Change Notification Number: 1228

Change Title: Product range update

Affected Products:
UL94-V2 material:
CTSN435/12, CTSN435/12W, CTSN435/12R, CTSN435/12WR
UL94-V0 material:
CTSN535/12, CTSN535/12W, CTSN535/12R, CTSN535/12WR
UL94-V0 GF material:
CTSN635/12, CTSN635/12W, CTSN635/12R, CTSN635/12WR
(and smaller pole sizes derived from these)

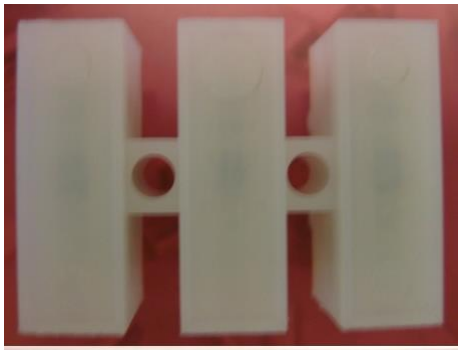
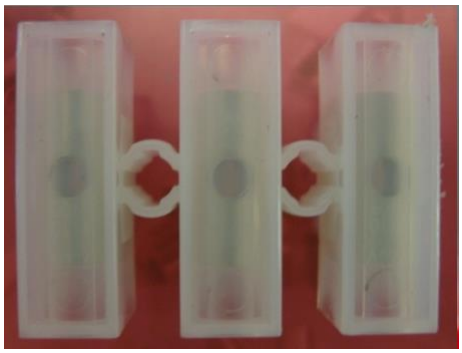
Description:
Due to a tooling upgrade the above mentioned products will feature:

1. Guided wire entries - moulding fits the shape of the metal inserts preventing wires from straying outside the inserts.

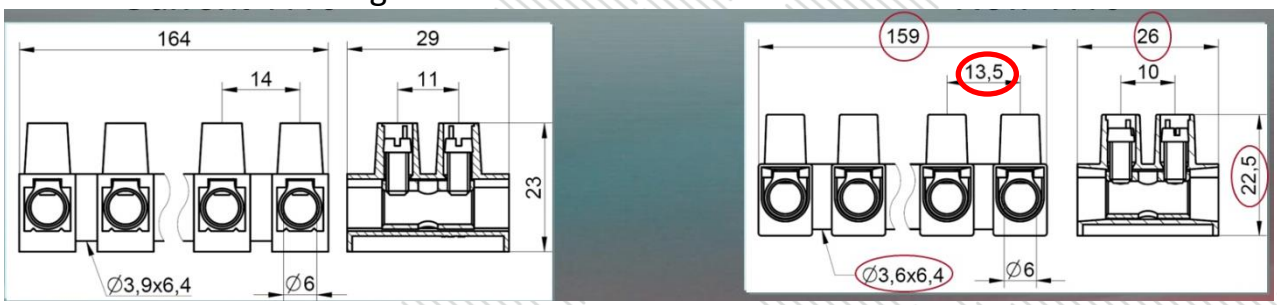
4. Dimensional changes:

Due to the change in pitch, a new part number will be issued:
CTSN436/12 (UL94-V2)
CTSN536/12 (UL94-V0)
CTSN636/12 (UL94-V0 GF)
